### **DELAWARE STATE UNIVERSITY**

### Addendum #02

Project: Alumni Stadium Stormwater Drainage

Contract: FD-15-128

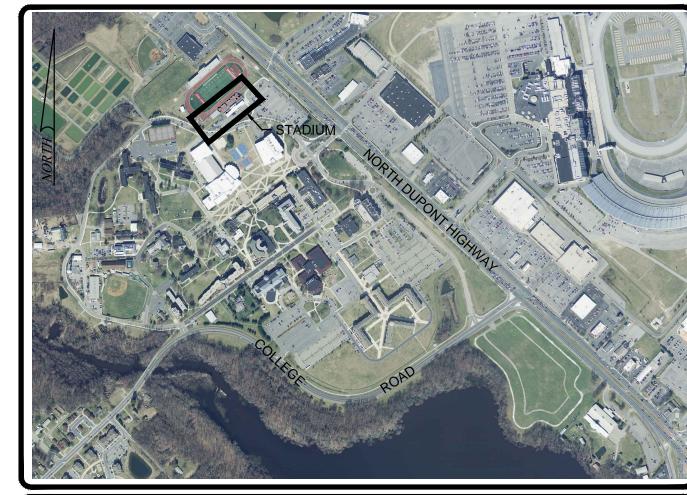
1. **Question:** Will the vending booth under the stadium be removed prior to paving, and

or will it be paved around?

**Answer:** The vending booth will not be removed. Please refer to the attached

revised drawings.

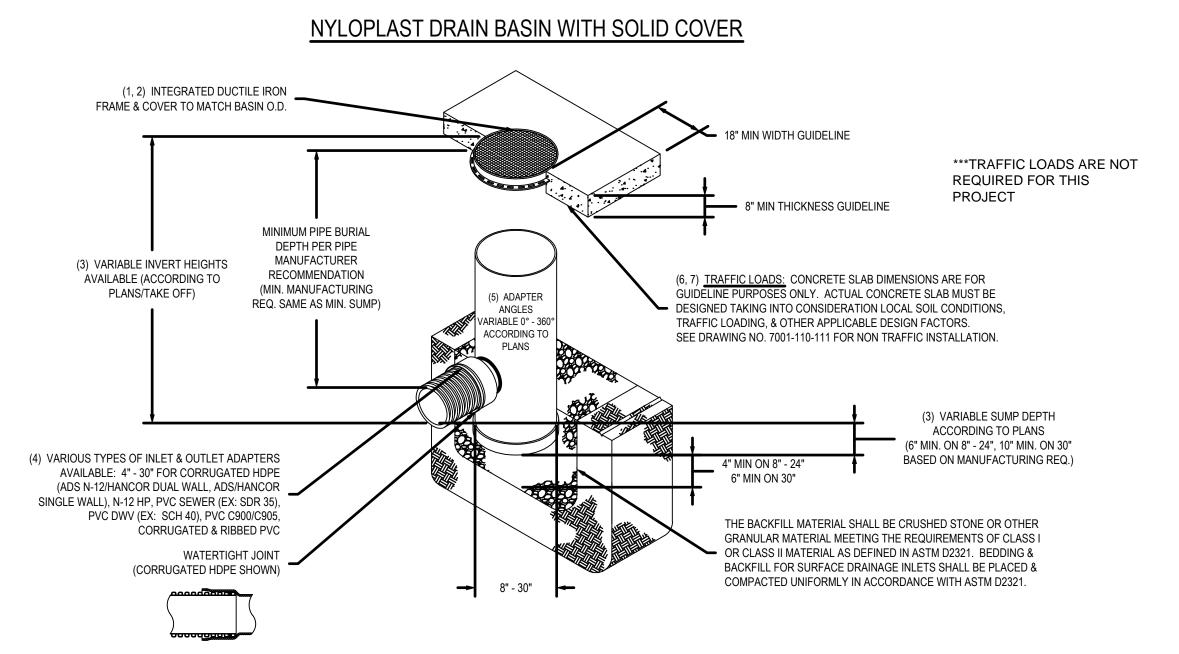
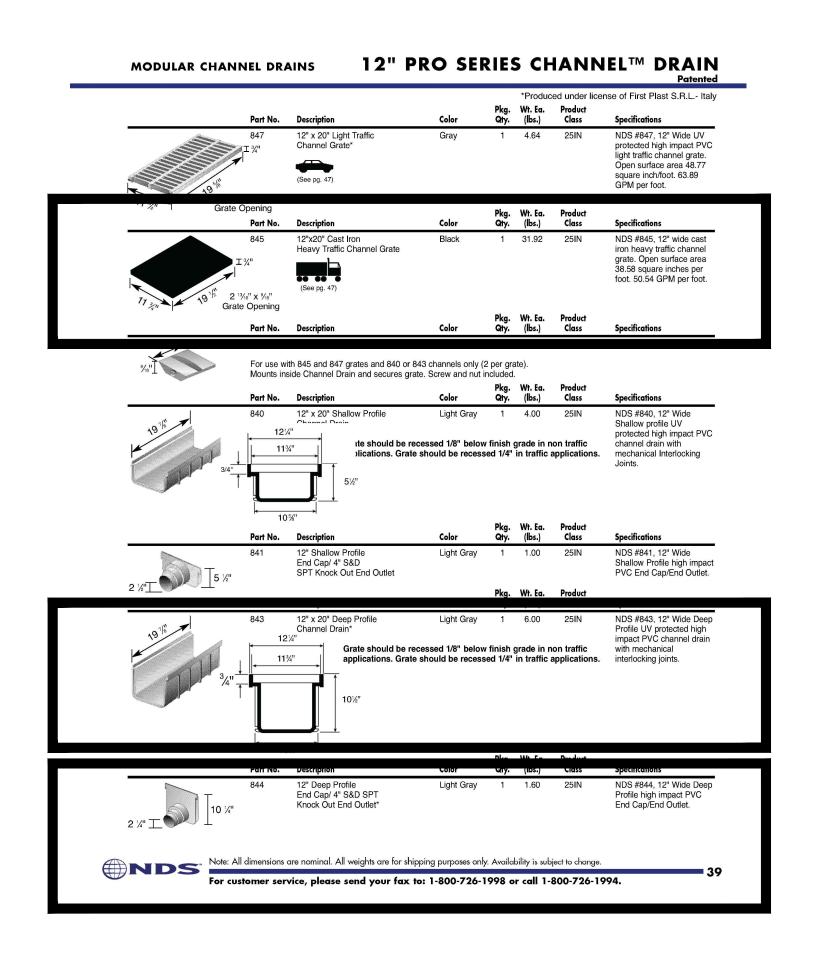
2. **Question:** Can the engineer provide a spec and detail for the type of trench drain to

be used.

**Answer:** Please refer to the attached revised drawings for a spec and tranch drain

details.
